Product Change Notification / GBNG-19TOBI439

CCB 4885 Final Notice: Qualification of CEL-8240 GS as a new mold compound material for selected Supertex CL2xx, CL52xx, LND150, MCP15xx, MCP170x and MCP970xx device families available in 3L TO-92 package assembled at CRTK assembly site.

CCB 4885
Pre and Post Change Summary
PCN #: GBNG-19TOBI439

Lead Frame Comparison

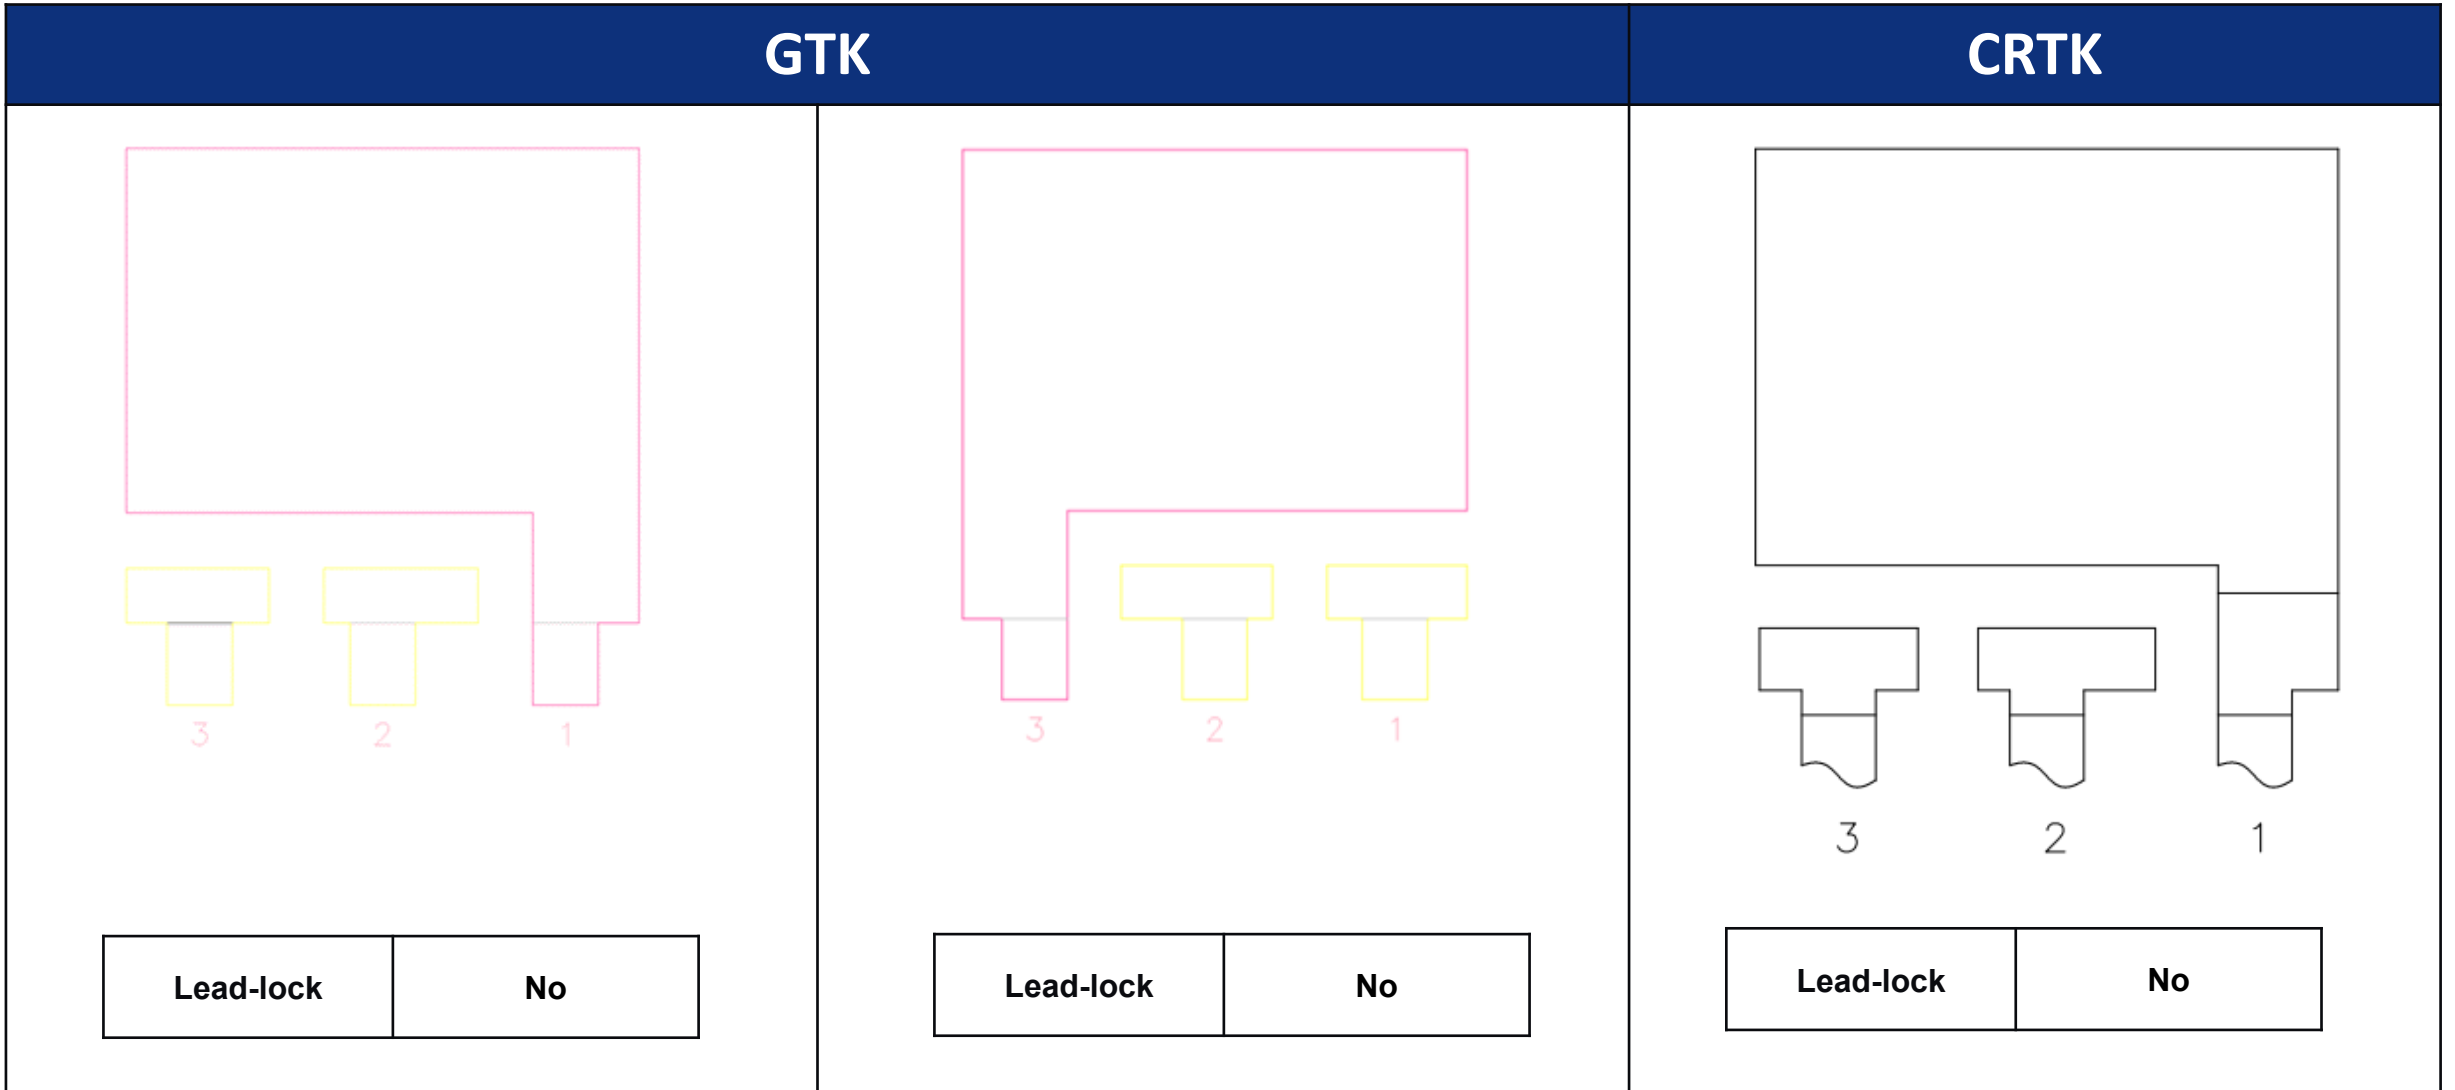
Note: Mold compound material fills the leadlock hole, which provides improved protection against moisture penetration along the edge of the leads (pins) of the package.

Package Lay-out

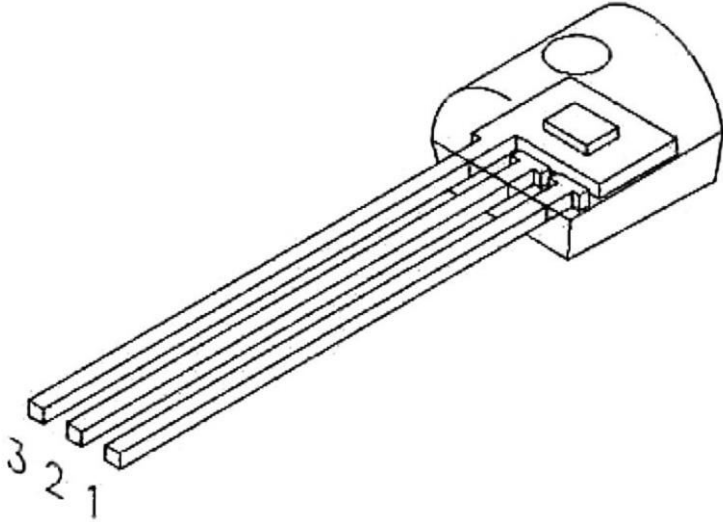
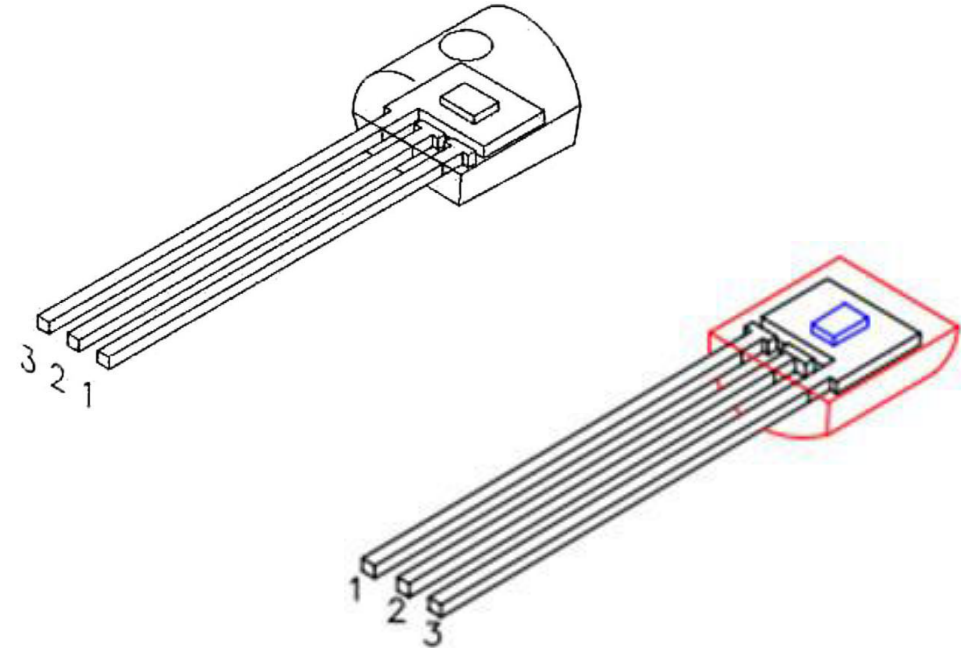
March 15, 2022: Issued final notification. Attached the Qualification Report. Provided estimated first ship date to be on April 20, 2022. Updated the package lay-out in Pre and Post change comparison (ppt file) for CRTK – Die sit either flat side or curve side depending on die or BD lay-out on some devices.

Note:
Die sit on flat side or curve side depending
on die or BD lay-out on some devices
